LETTER OF DENIAL

RE: 147 Woodcleft Avenue, Freeport, NY

Building Permit Application #20243675

Description: Proposed 1-story side addition (224 Sq.ft) , 1-story addition (169 Sq.ft) , 2nd story terrace (930 Sq.ft) , roof over deck (424 Sq.ft) and wood shades (240 Sq.ft)

SITE PLAN
SCALE: 1" = 10'

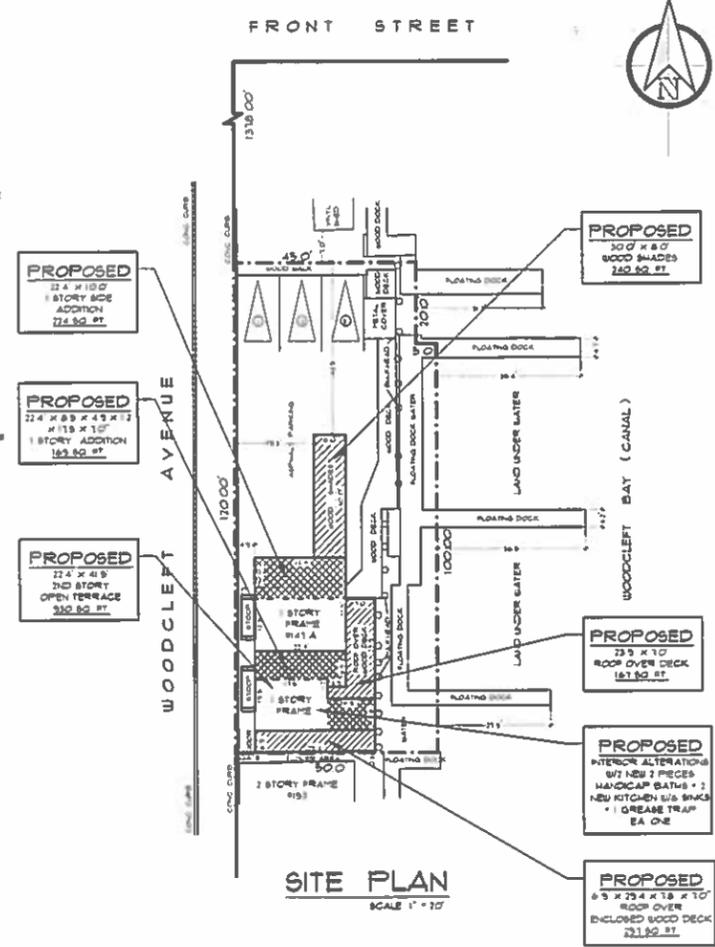
Every structure shall be so situated on its lot as to provide front and rear yards of not less than five feet in width and one side yard of not less than 10 feet in width, except where such lot has a width of 40 feet or less, in which case no side yard is required, and except along streets where greater setbacks have been established. No rear yard shall be required where the rear yard of the lot abuts on a canal or waterway and said lot has a depth of less than 60 feet. According to the drawings indicates that you have a .20' front yard. You will be seeking a variance of 4.8'.

(4) Restaurants, discotheques, cabarets and bars: at least one parking space for each three authorized occupants. The drawings indicate 8 tables with 4 seats with a total of 32 seats provided. You will need a total of 11 parking spaces and only 3 are provided. You will be seeking a variance of 8 parking spaces.
